Appendix I – Response to Comments on the 90% Design Documents (Basis of Design Report, O&M Manual, Construction/Remedial Action Work Plan)

Groundwater Remedy Basis of Design Report/Final (100%) Design

PG&E Topock Compressor Station, Needles, California

(H1) SECTION
3/4" = 1'-0"
C-07-25

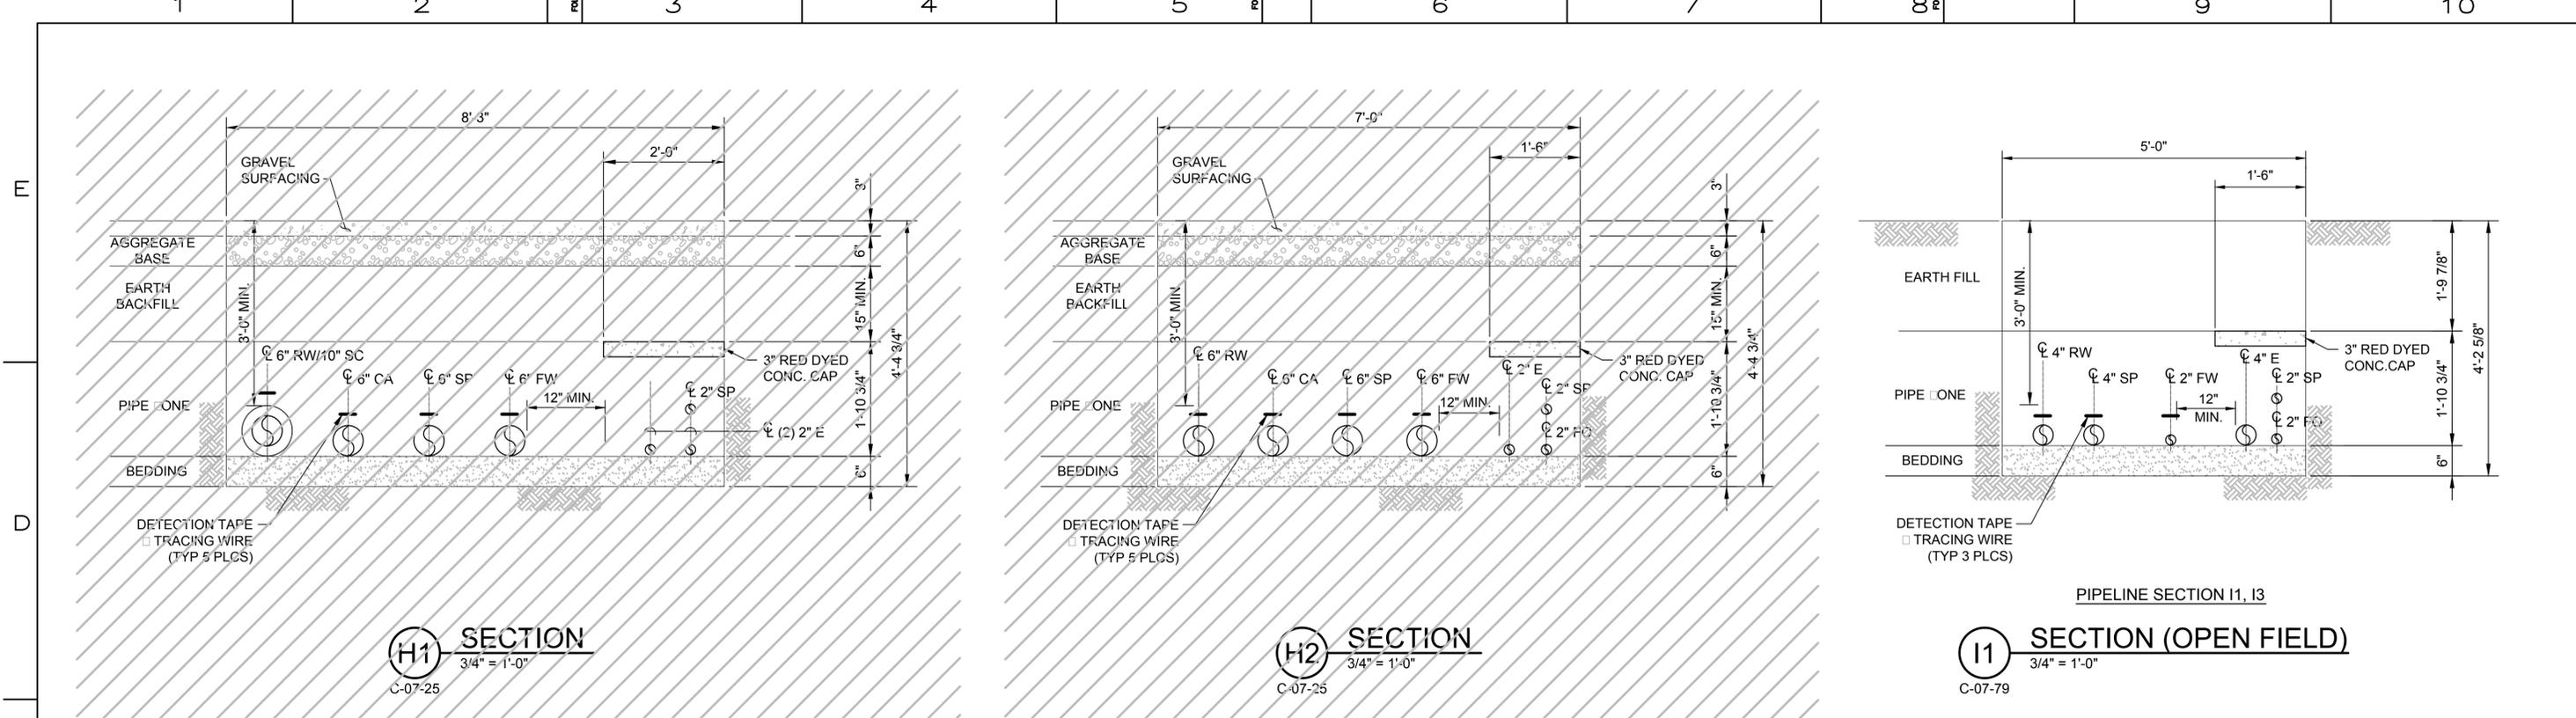
558	Chemehuevi/TRC	Design	Infrastructures	Append. D	C-07-106	Why is there 12" spacing between electric conduit and water pipelines in underground trenches on previous sheets, but less than 12" spacing in the open air concrete trench? If power and water are so close together in the concrete trench, why is there so much spacing for water lines in concrete trenches and direct bury electrical conduits?	See above				
559	FMIT	Design	Infrastructures	Appendix D; C-07-107	CH2MHILL 90% Design Plans	Why is there 2' of spacing between two separate trenches for water and power lines? Detail L3 and K1 show 480V electrical lines within 12" of water lines.	See RTC #21 FMIT-7.				
560	FMIT/TRC	Design	Remedial Design	Append D AND Supplemental Section 3	Design group "09" Compressor Station Ponds	There appears to have been no effort made to estimate the CUMULATIVE noise impacts resulting from this, or other major segments (e.g., TCS improvements) of this project. This is important considering both the duration of the build-out, and the long-term operation of the remedy. The approach appears to be to design and construct, and then see if complaints arise, and if there are complaints, to then attempt to deal with the issues. Instead, the designers should quantify in advance the projected cumulative noise level impacts resulting from planned improvements at such locations. As an illustration, for the TCS evaporation ponds segment of the project, partial sound level information is provided in Appendix D, Equipment List D1-12 for the natural gas generator that will power the facility.	Certain TCS improvements, such as the new air compressor building, are not part of the project. Improvements to the ponds, however, are part of the project. The cumulative noise analysis for the project can be found on page 6-38 of Volume 2 of the EIR. The analysis accounts for the possibility that the project may be constructed at the same time as unrelated projects at the compressor station, as well as noise from I-40, the railroad, and other existing noise sources in the area. According to this analysis, the project will not make a cumulatively considerable contribution to cumulative noise impacts if the project complies with Mitigation Measures NOISE-1, NOISE-2, and NOISE-3. The approach for this project is to comply with the applicable regulatory standards that are set to protect certain resources and/or receptors and implement the mitigation measures specified in the EIR. The County's noise standards	DTSC has considered cumulative impacts of all known projects in the Certified EIR. Noise impacts are evaluated against regulatory thresholds. DTSC understands that culturally, Tribes may consider noise differently than regulatory thresholds, thus DTSC evaluated the potential cultural impacts of the project and considers it significant and unavoidable.		Now that the design is close to 100% complete, the Subsequent Groundwater EIR should include a comprehensive cumulative noise impact evaluation that considers the project as it now exists, because the project has changed in important ways. Therefore, this comment is considered unresolved.	DTSC Response: Comment noted. Noise impact and cumulative impact are subject areas that DTSC will consider in the upcoming SEIR.

Design of New 12-inch Freshwater Pipe for Use if Pre-treatment is Required

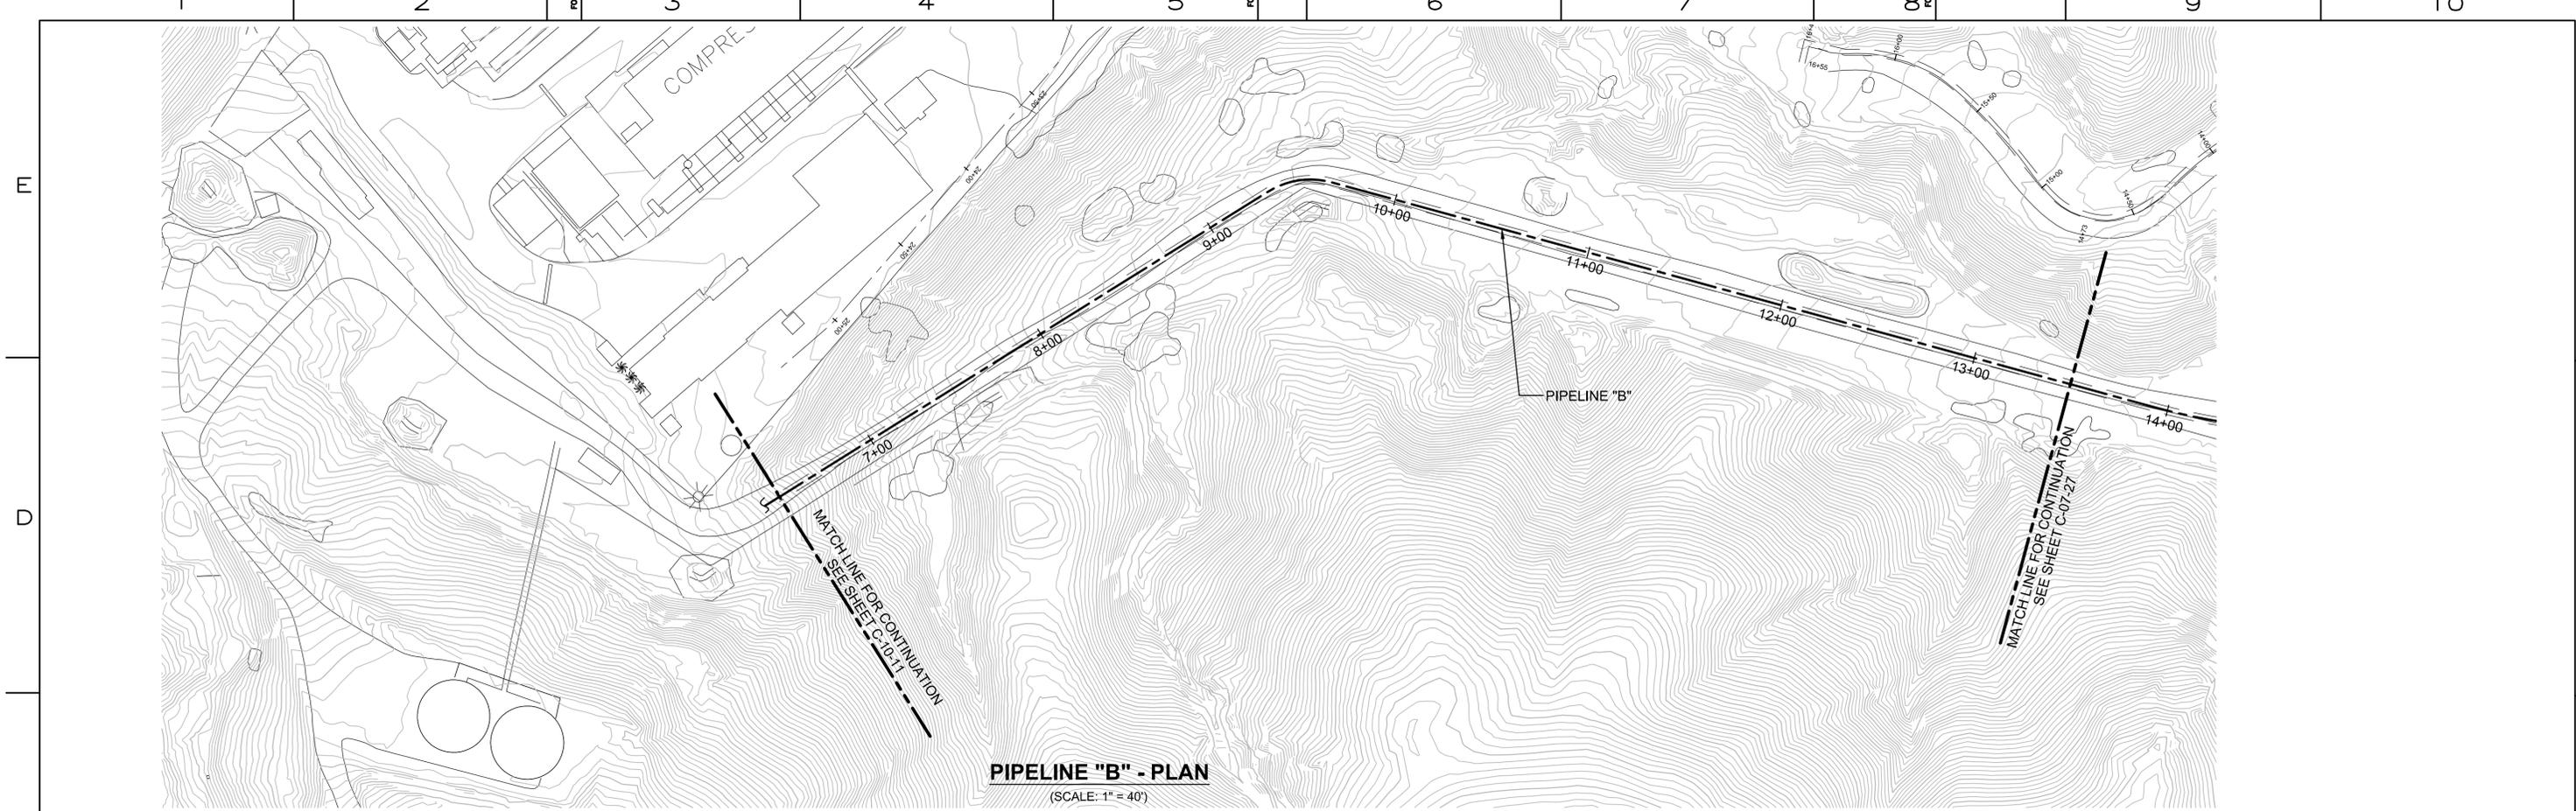
298	Cocopah/TRC	Design	Request for Information	3.3.3.1 Figure 3.3-1 Freshwater Supply Piping Network	In the event that pre-treatment of fresh water is required, all fresh water will be piped to the Compressor Station for treatment, and the treated fresh water will be conveyed along the entrance road prior to joining the freshwater	Please discuss how pipeline runs will be modified in the case that pre-treatment is required. How much new pipeline and/or trenching will be required. What will the new flow paths be in the case that pre-treatment is required?	See above			The incorporation of design accommodations for possible future additional pipeline runs, while planned for in existing trenches, represents an incremental expansion of underground piping that needs to be addressed in the SEIR.	DTSC response: Tribal comment noted.

Revised C/RAWP Figure 4.2-3

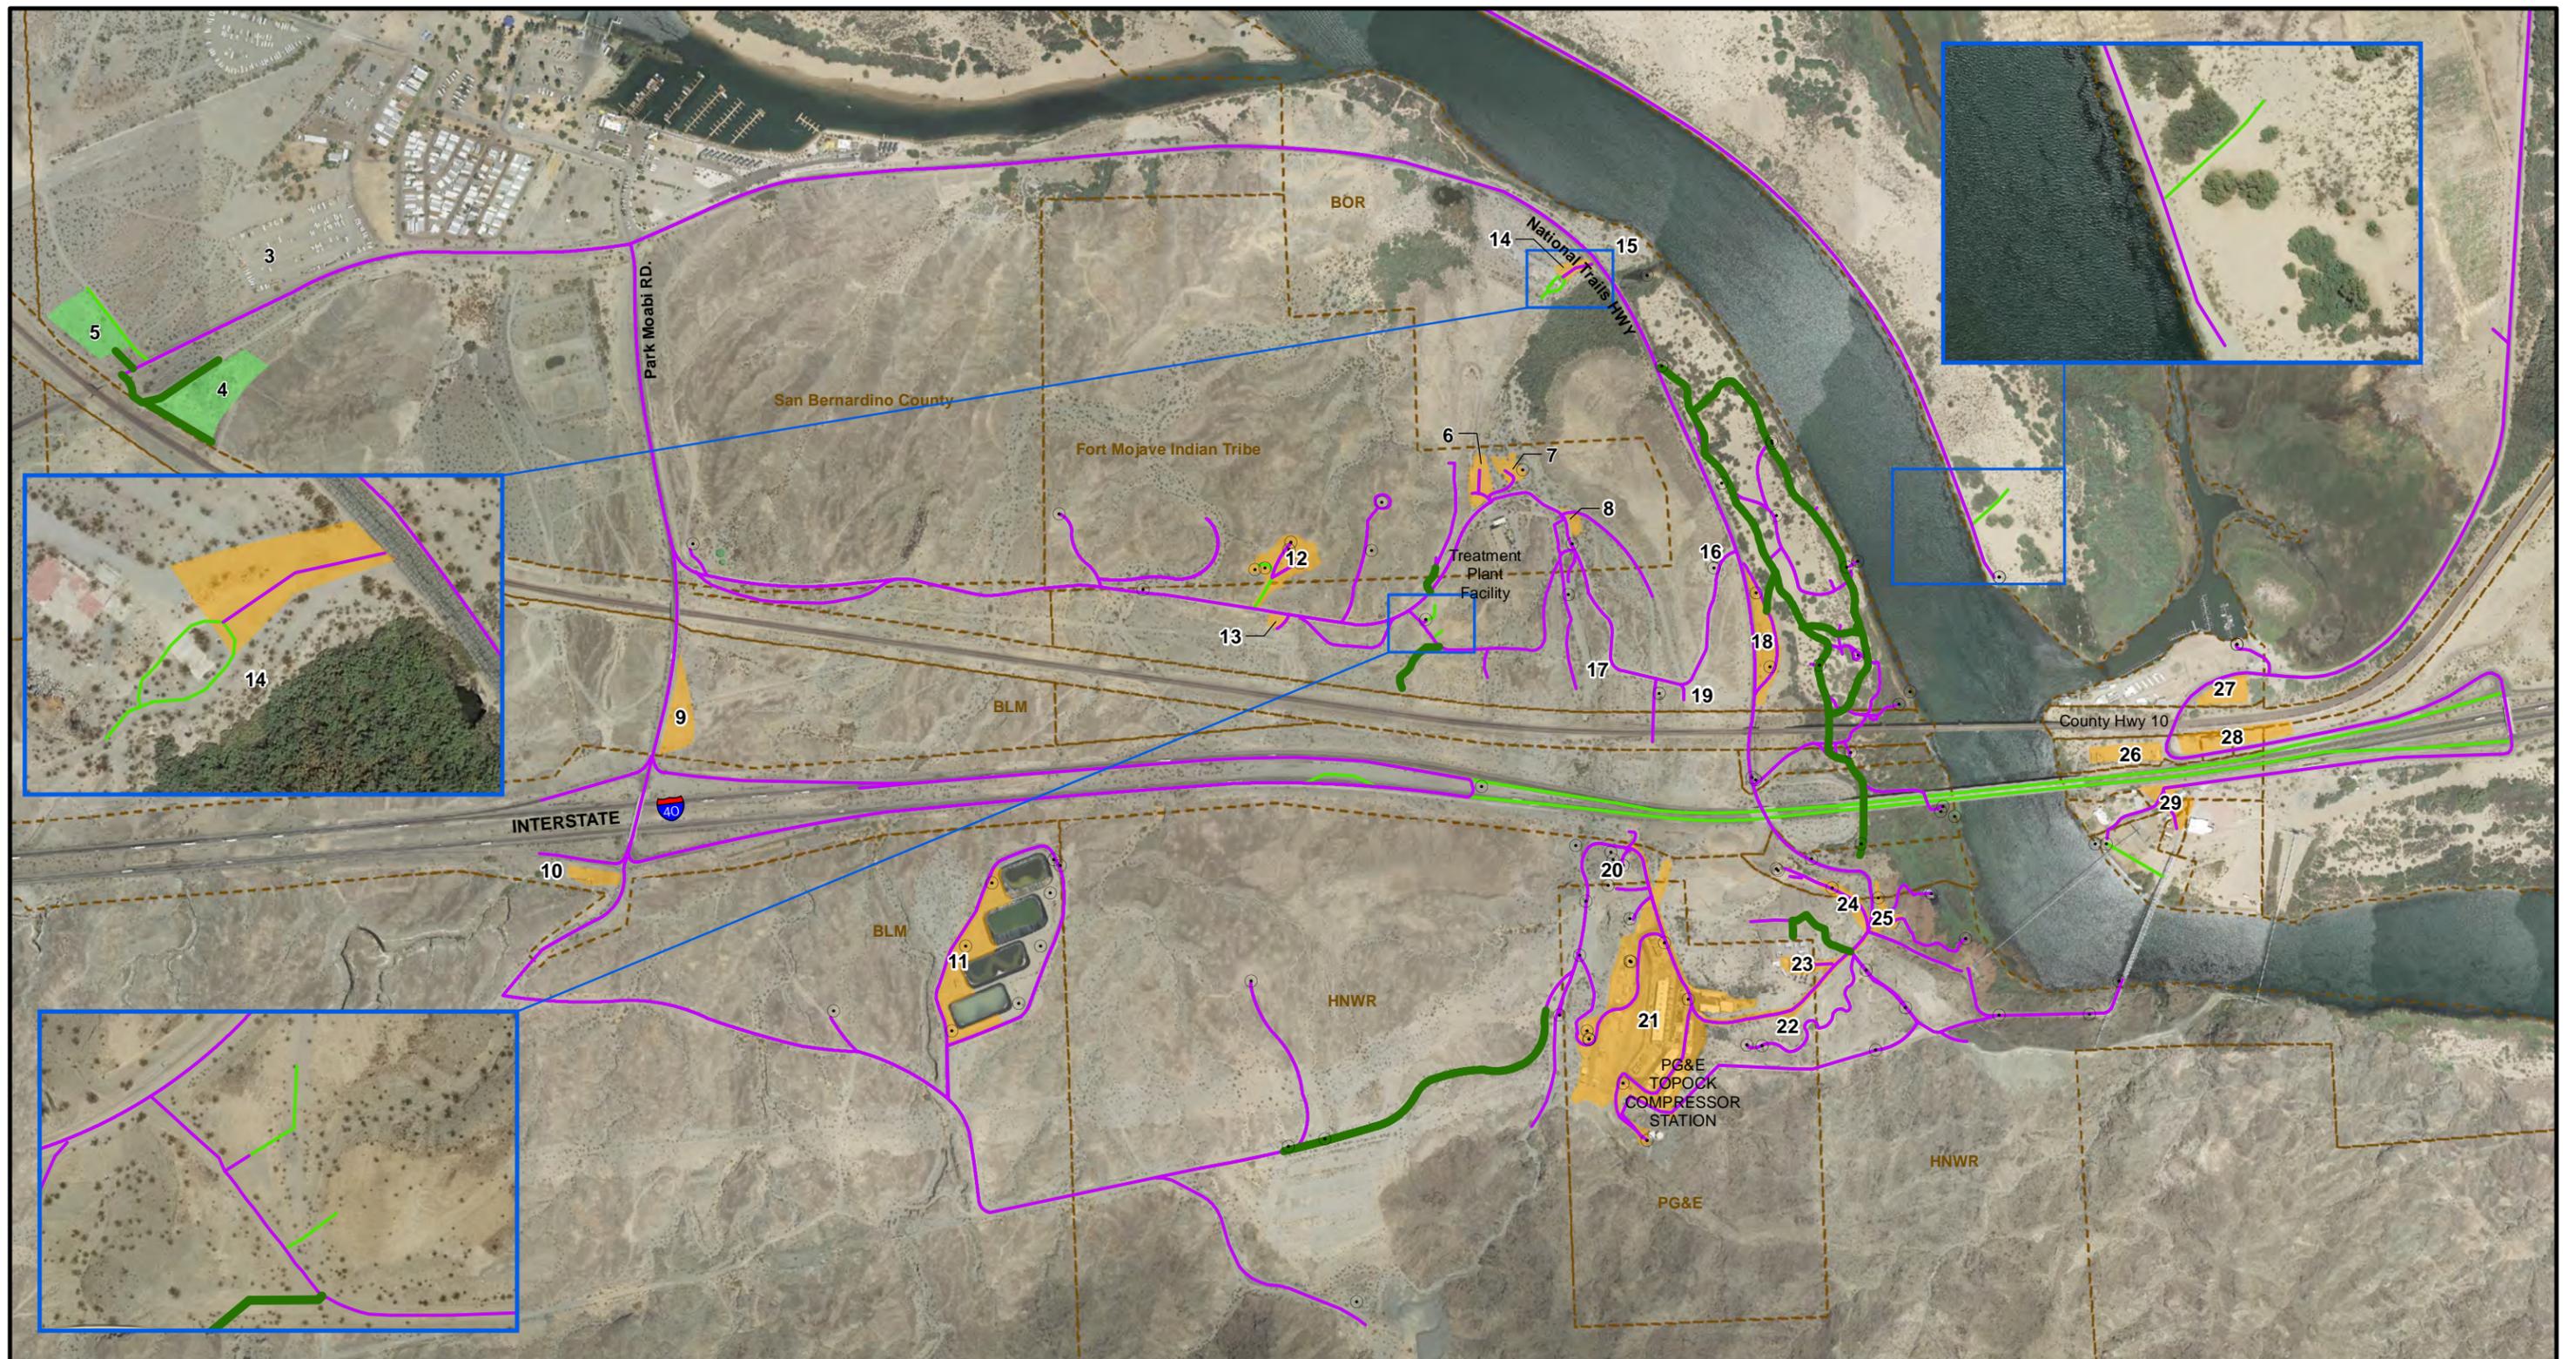
105	FMIT-20	Design	Infrastructures	ES.3. p. x	5 th bullet describing staging areas and support zones	FMIT is opposed to certain staging areas/support zones identified. This is discussed further in regard to Figure 4.2-3 of the C/RAWP.	Please see RTC #860 FMIT/TRC, #861 Hualapai/ TRC, #862 Cocopah/TRC, and #863 Chemehuevi/TRC.				This RTC and other RTCs related to staging areas were discussed at the July 23, August 19, and August 26 TWG meetings.
106	MWD	Non-design	Other	ES-4/xi; Sect. 5.0/5- 1; Figure 5.1-1	Institutional Controls	Figure 5.1-1 shows the line for the approximate area for Category 1 Institutional Control going through the top left corner of Metropolitan's property. Section 5.0 is silent on property owned by Metropolitan that is within the southeastern area of the designated Area of Potential Effects (APE). Either the APE boundary should not include Metropolitan's property, or access and other control issues should be described.	As noted, the APE boundary includes a small area of MWD’s property. At this time, PG&E does not propose groundwater remedial infrastructure nor plan to conduct remedial activities on MWD property. Therefore, PG&E does not request access to MWD’s property for the purpose of remedial or investigative activities. Further, in discussions with DTSC and DOI, a Category 1 IC is determined to not be necessary at this time by the Agencies for the MWD property. The need for and effectiveness of institutional controls for the remedy will continue to be evaluated in the		The APE refers to the geographic area or areas within which an Undertaking may directly or indirectly cause alterations in the character or use of historic properties. The APE for this Undertaking was initially comprised of 1,600.69 acres of surface area, 325 and a section of the Colorado River. The Programmatic Agreement (PA) notes that “At each phase (workplan or design document) of implementation of the Undertaking, an evaluation will occur to determine if the APE should be amended.” This		Comment resolved.
